Rye Park Wind Farm (SSD 6693) Independent Environmental Audit FINAL

Client: Rye Park Renewable Energy

May 2023

Photo 1: Road drain with rock check dam silted up and ineffective

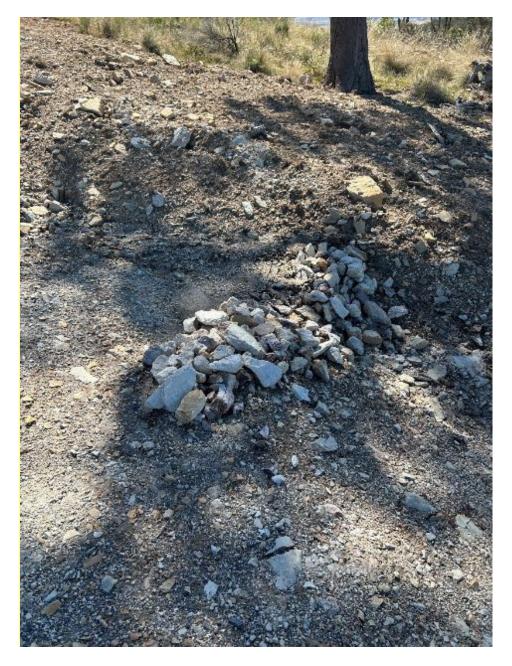
3.18 (b) SOIL AND WATER Operating Conditions	 Some check dams along road drainage are being bypassed or are filled with sediment and need to be cleaned (See App D photos 1-3) Some batters need stabilising including a steep batter at B15 hardstand (see App D Photo 4) There is significant erosion caused by spillage from a standpipe at the northern batching plant (see App D photos 5-6) Recently laid cable runs need seeding to establish ground cover (see App D photo 7) Sediment fence repair is required south of B11 where the cable run is eroding and there is the potential for sediment to leave the site (see App D Photo 7). 		
	OFI:		
	 Regularly maintain rock check dams Stabilise batters and cable runs immediately after works are completed Ensure standpipes do not overflow onto steep unstabilised slopes Ensure sediment fencing is maintained downstream of disturbed surfaces.

Photo 2: Road drain with rock check dam partly silted up and breached and ineffective.

Photo 6: erosion caused by spillage from a standpipe at the northern batching plant (2)

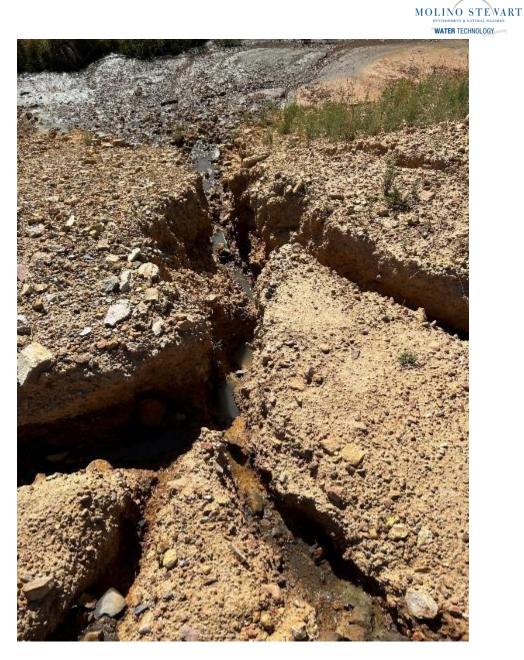
Condition Number	Requirement	Evidence Used	Findings and Recommendations	Compliance Status
	(e) ensure the concrete batching plants and substation are suitably bunded; and	observations	Substation was not visited but northern concrete batching plant site was. There was significant erosion caused by spillage from a standpipe	Compliant

Photo 5: Erosion caused by spillage from a standpipe at the northern batching plant
